NRL Report No. B-1096

Telephone Extension Relay

Automatic Electric Company
Chicago, Illinois.

NAVAL RESEARCH LABORATORY
ANACOSTIA STATION
WASHINGTON, D.C.

PLATE 1

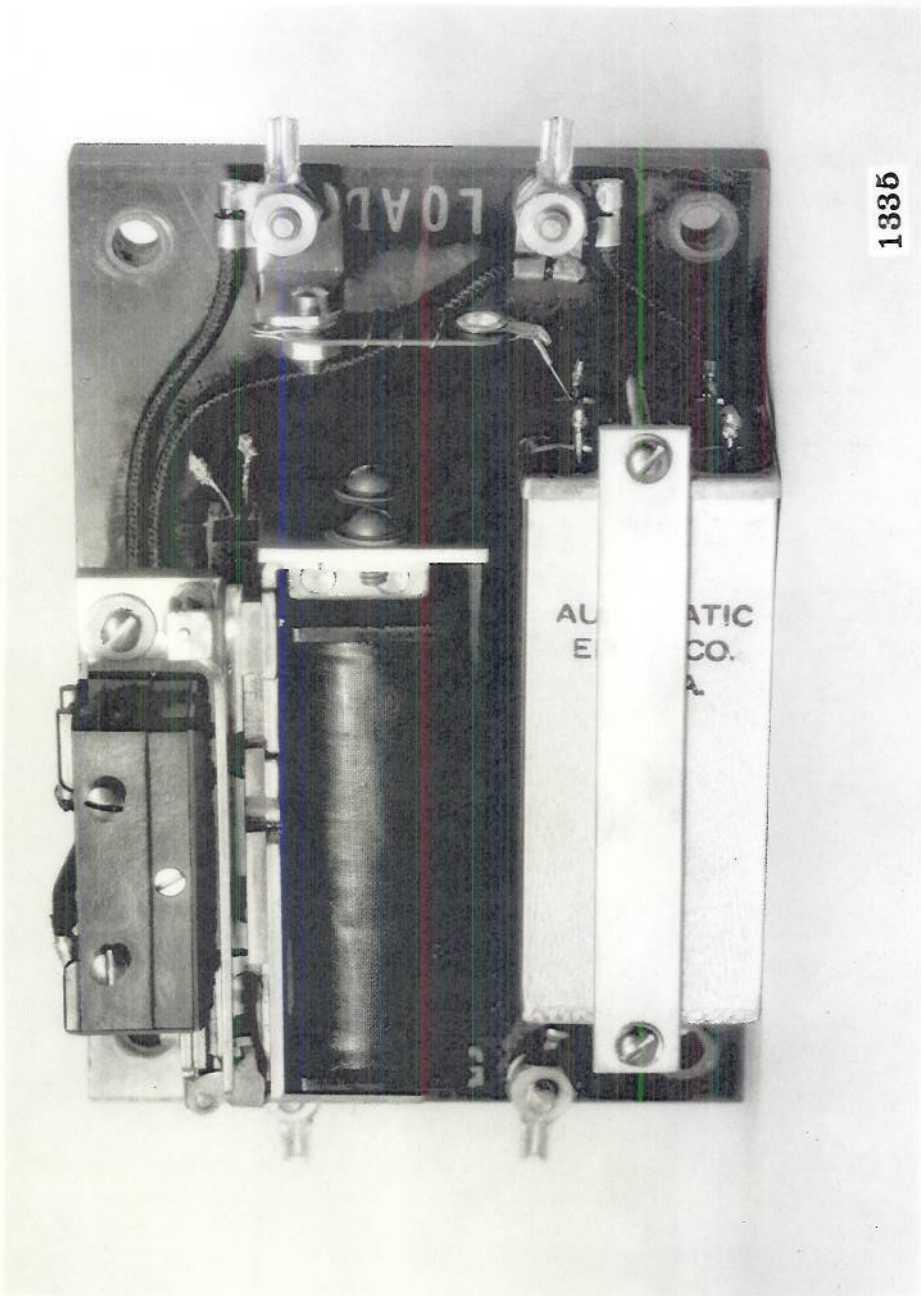
(a) This relay as submitted by the Automatic Electric Company is not satisfactory for installation in ships service telephone systems because of its failure to comply with the requirements of the specifications with respect to shock integrity.

(a) That the relay, as submitted, be not approved for the Naval service because of its failure under shock.

9. The entire unit is mounted on a base of approved insulating material and enclosed in a watertight cast aluminum alloy case provided with 3 bosses drilled and tapped for 3/4" Navy terminal tubes. Four lugs are provided on the case for mounting. The relay as received is shown on Plate I.

14. The glass enclosed contacts on the relay as submitted were injured under shocks of 150 foot pounds causing the alarm circuit to remain closed. In view of this a "Burgess Micro Switch" was substituted and found capable of withstanding shocks of 150 foot pounds.
